Service Bulletin

SAFETY RECALL

2002-2005 VFR800/A Wire Harness Replacement

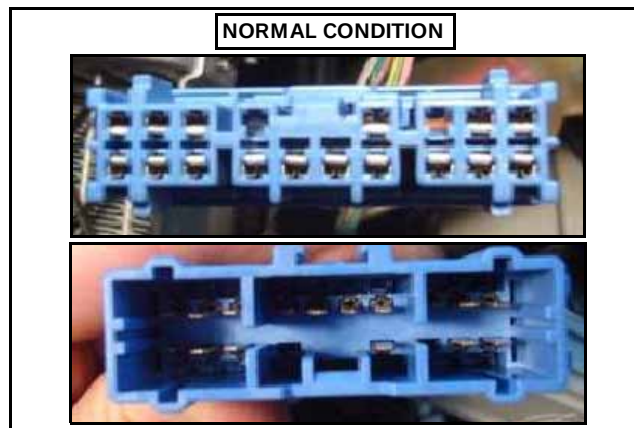
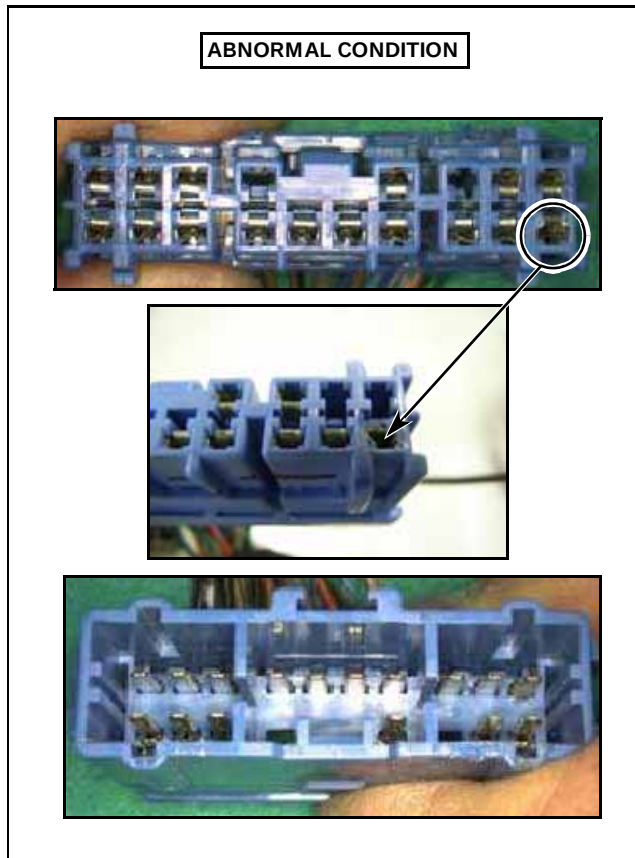
Inspect the 18P connector (light blue) inside the protective sleeve for any burnt, melted, or discolored condition.

If the 18P (light blue) connector is in abnormal condition as shown below, contact TechLine at (800) 421-1900, option 9.

If the condition of the 18P (light blue) connector is normal, proceed with the FRONT SUB-HARNESS REPLACEMENT.

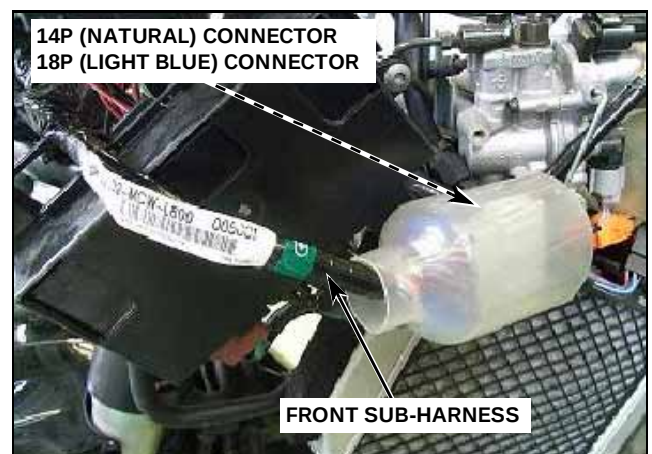
3. Install the new front sub-harness by connecting the 14P (natural) and 18P (light blue) connectors.

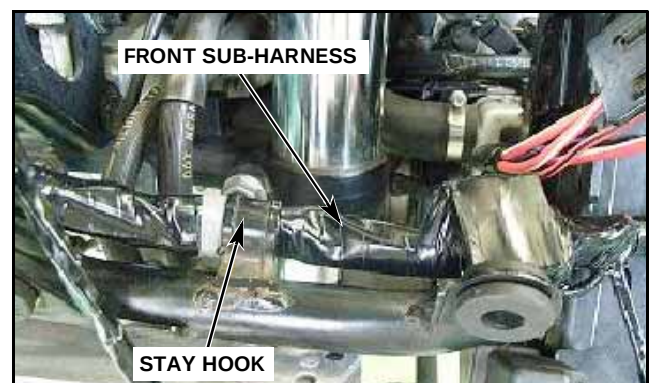
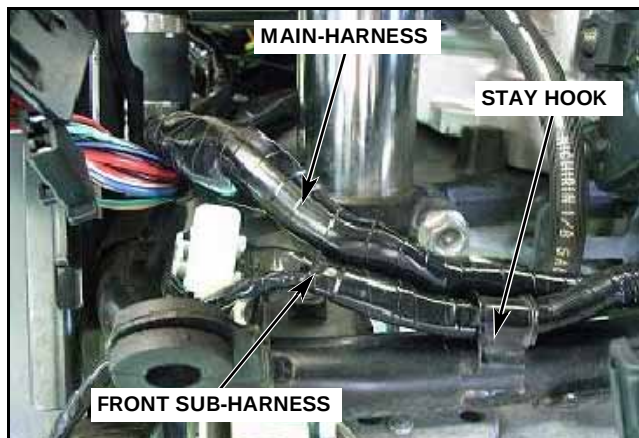
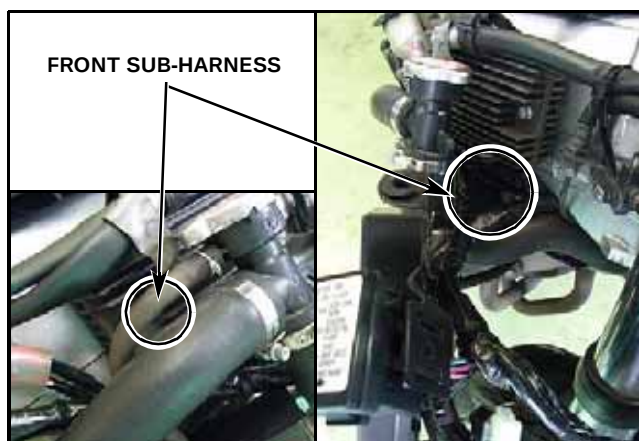
4. Attach the front sub-harness on the cowl stay hooks. Make sure the front sub-harness is routed below the main sub-harness.

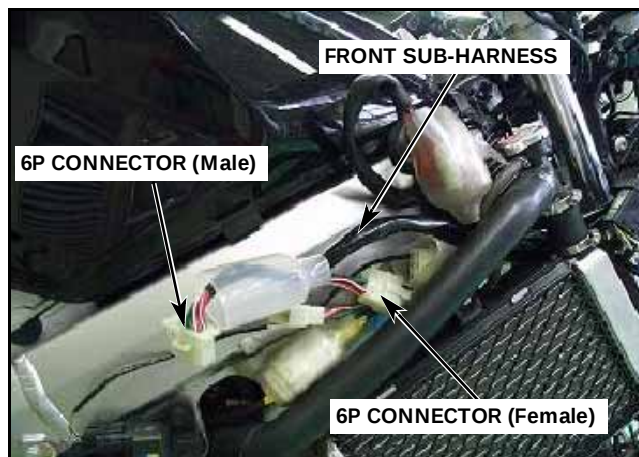
5. Place the front sub-harness between the radiator and the frame, and below the rectifier. Be careful not to damage the front sub-harness or other components.

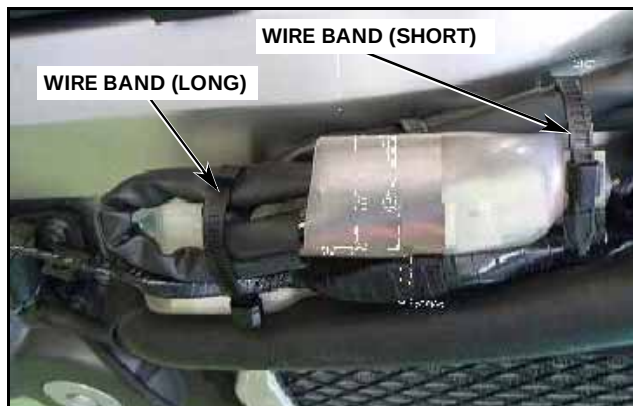
7. Secure the main wire harness and the front sub-harness using the longer wire band.

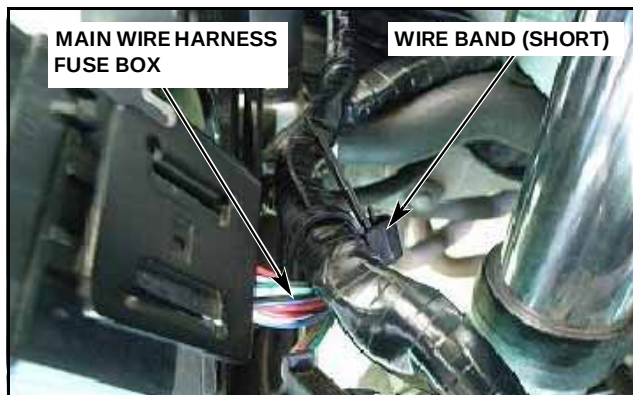
8. Secure the main wire harness and the upper side of the front sub-harness using the shorter wire band. Adjust the wire harness located within the frame and the radiator hose accordingly.

MODIFIED WIRING DIAGRAM

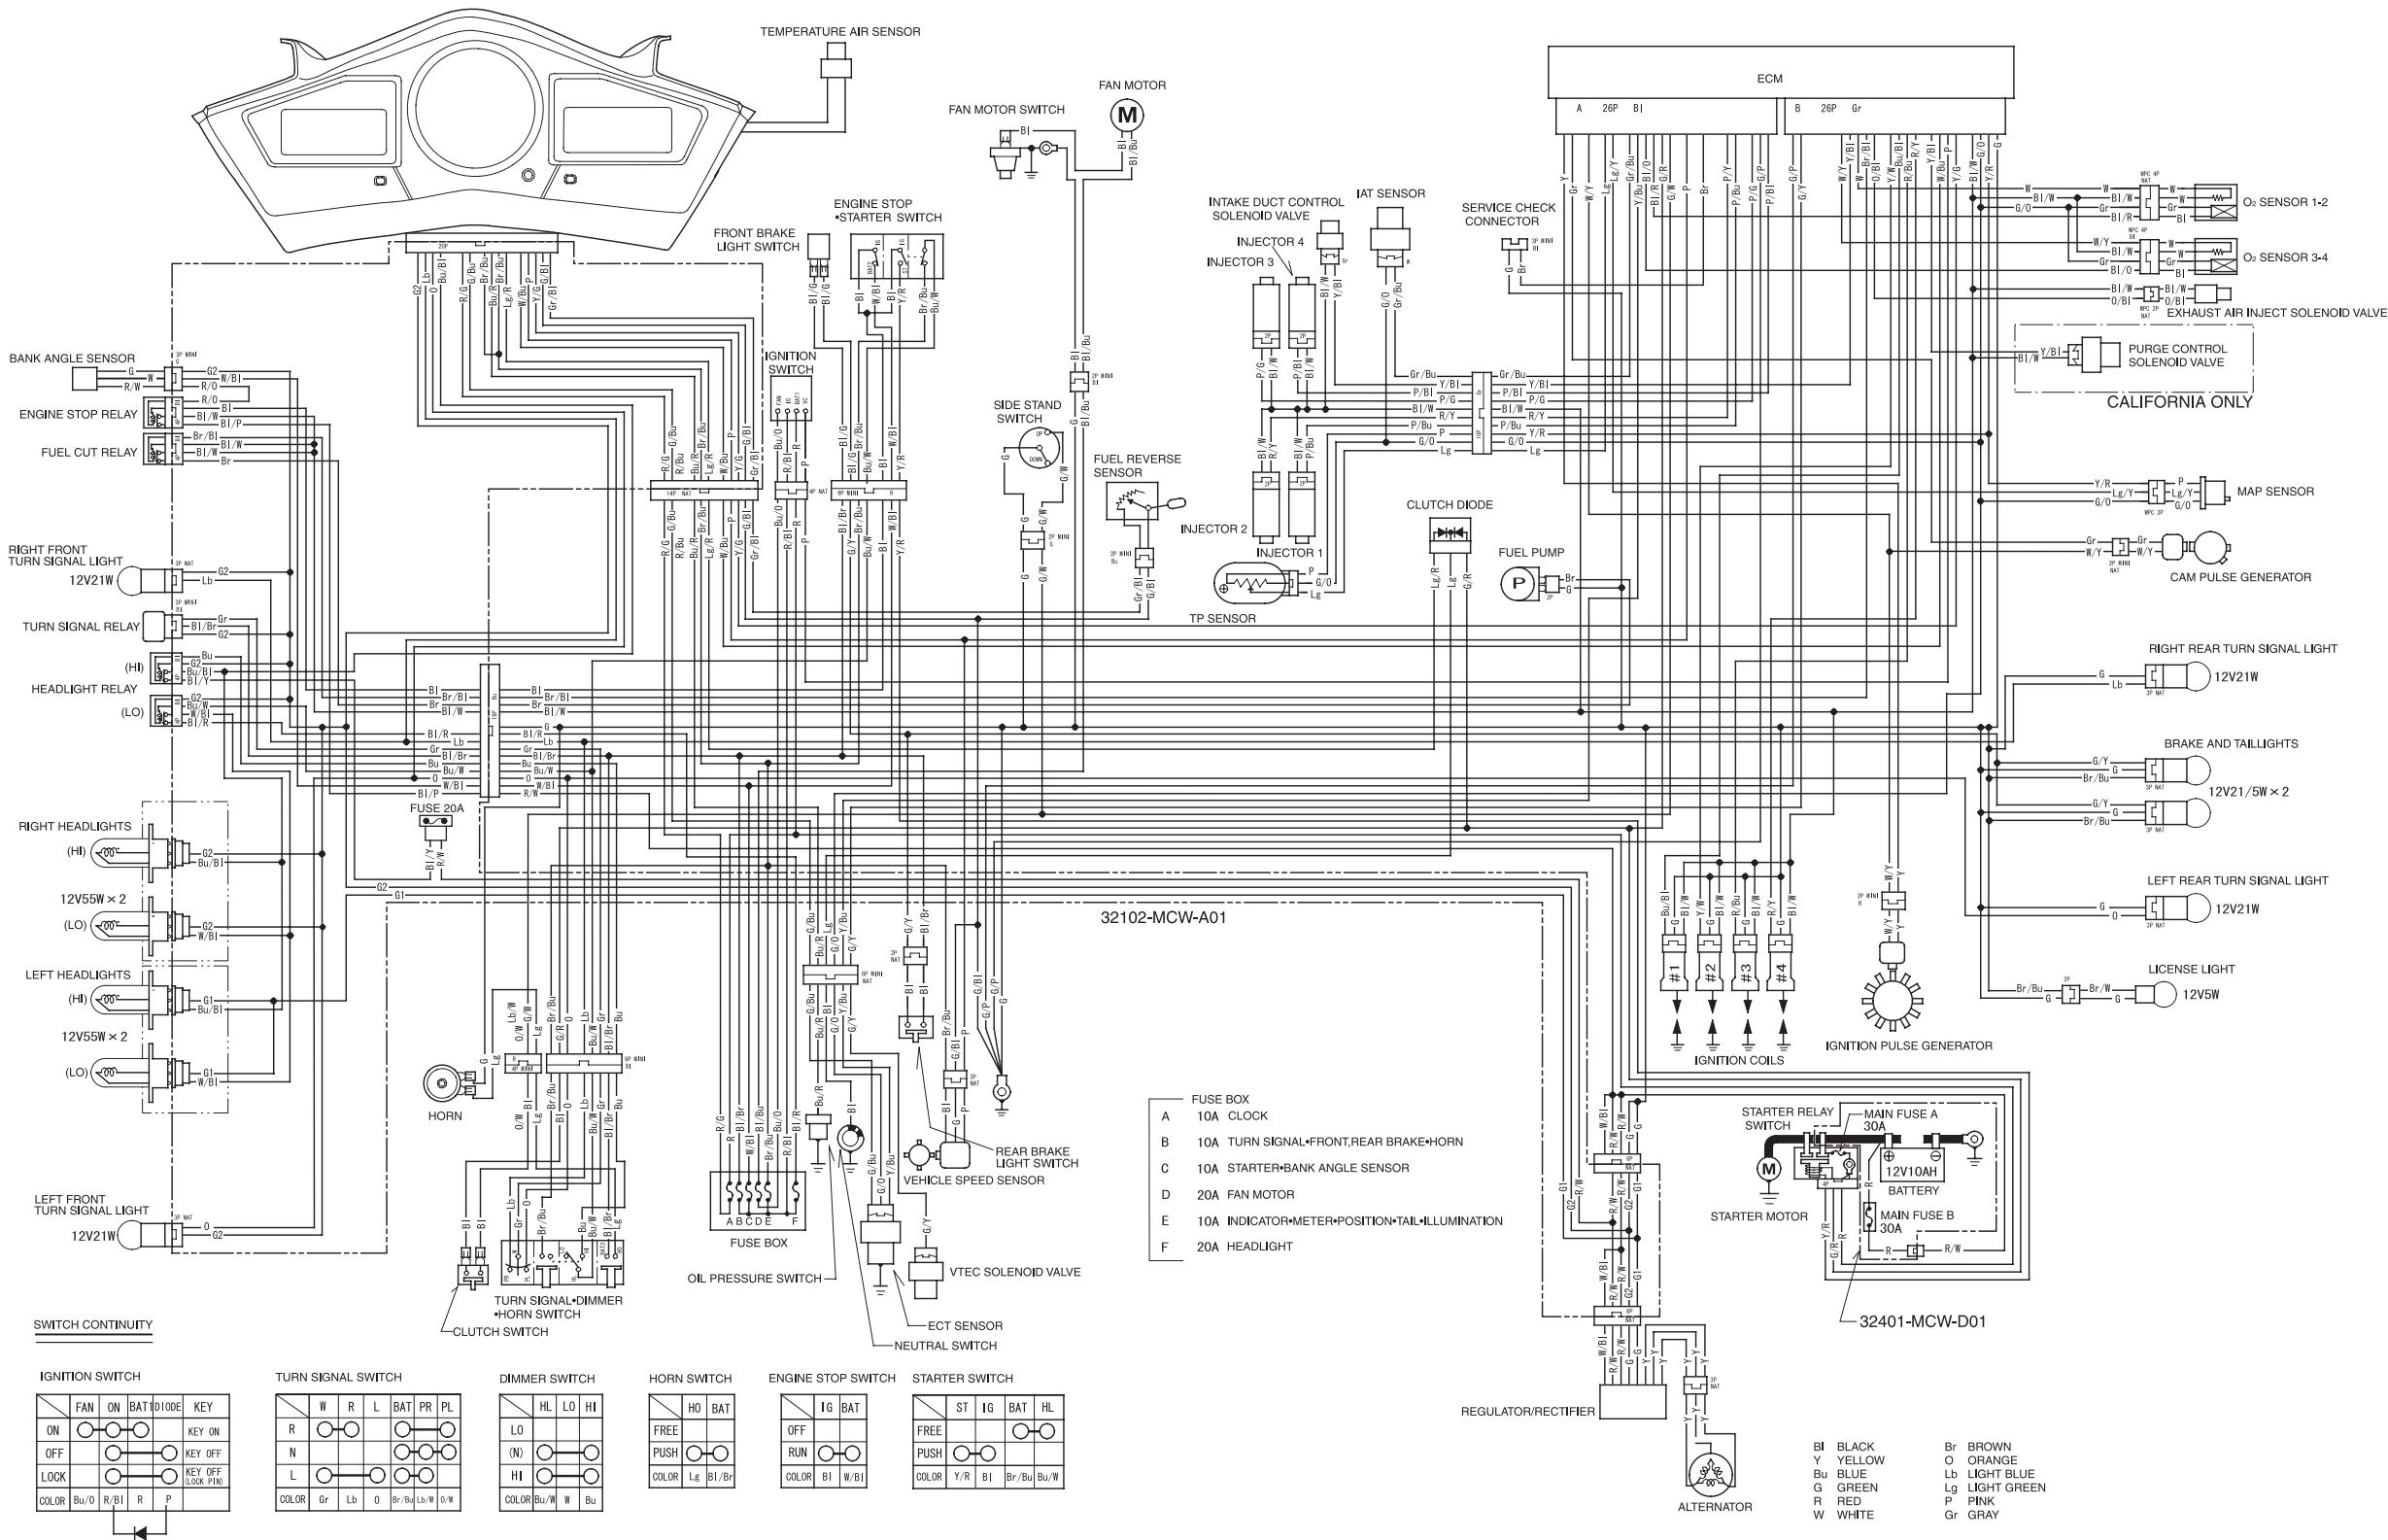
NOTE: Updated illustrations of the wiring diagram for the affected models are included with this Service Bulletin.
